E8363A-01B**S E R V I C E****N O T E**Supersedes:
E8363A-01A**E8363A PNA Series RF Network Analyzers**

Serial Numbers: 00000000 thru 46999999

Many of the Front Panel Interface (FPI) boards which were installed per Service Note E8363A-01A need to be modified or replaced because the RPG shaft can disconnect, and the front panel keyboard and RPG can respond intermittently upon boot up.

Figure 1

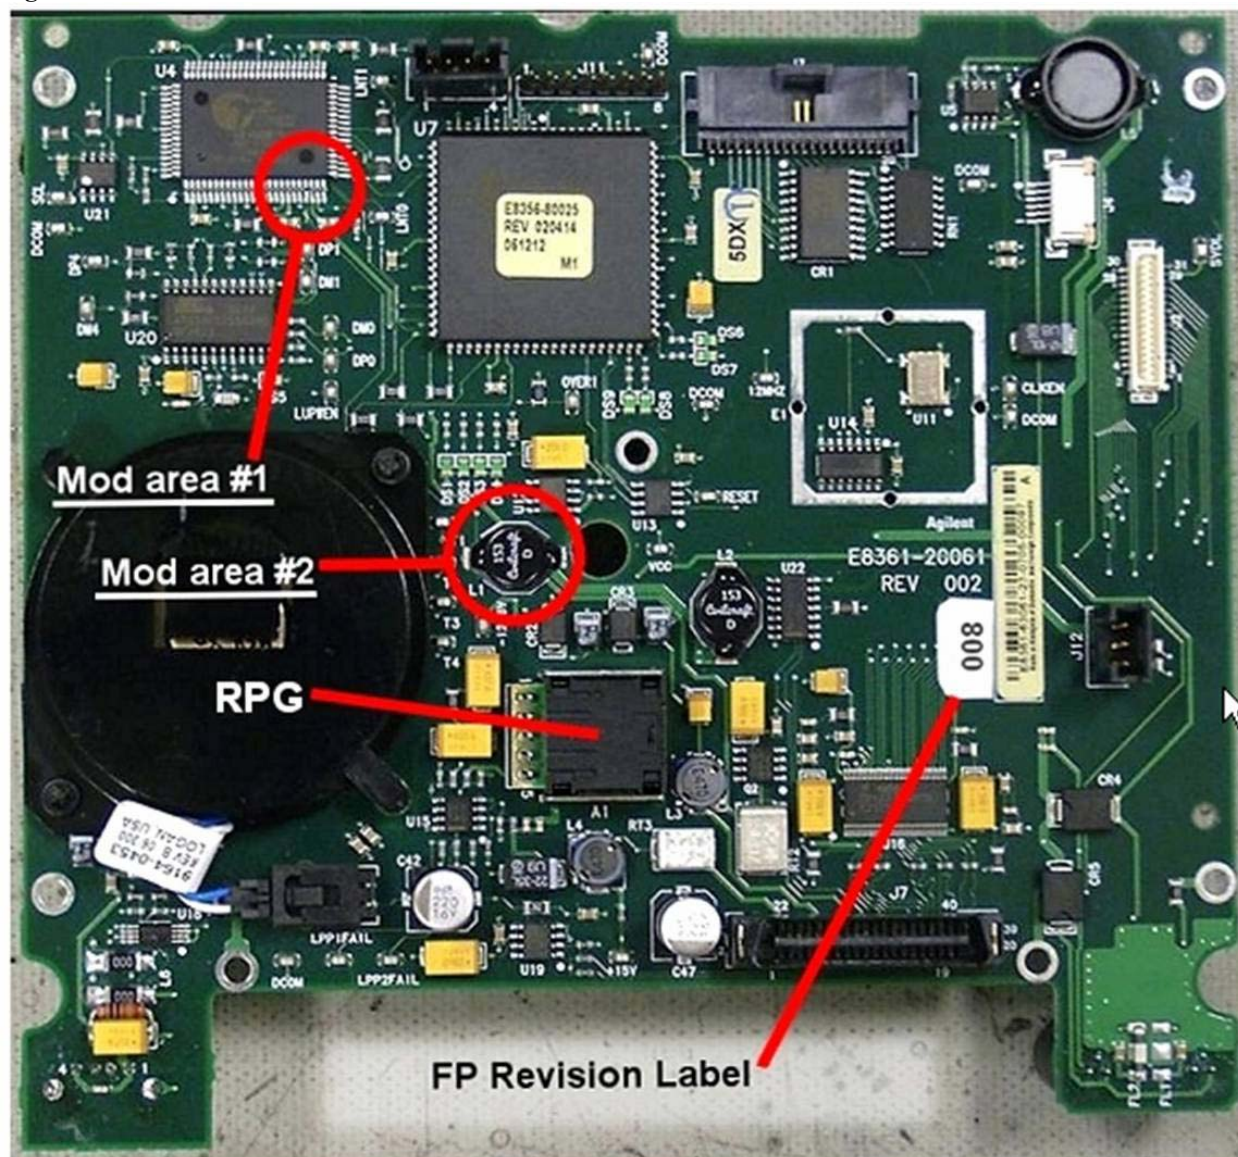
Refer to Figure 1 for the two modification areas to be addressed. Note that while this picture happens to show the FPI board completely removed from the front frame assembly, this is not necessary to perform the required modifications.

- Modification #1 consists of shorting two pins of U4 together with a small amount of solder.
- Modification #2 consist of removing L1.

Carefully solder pins 21 and 22 together on U4. Refer to Figure 2 for the exact location. Use care so that no other pins are shorted. Use of a very fine tip soldering iron is recommended and a large work-task magnifying glass is very helpful.

Unsolder and completely remove the black surface mount inductor L1 from the front panel assembly board. This is no longer needed and can be discarded.
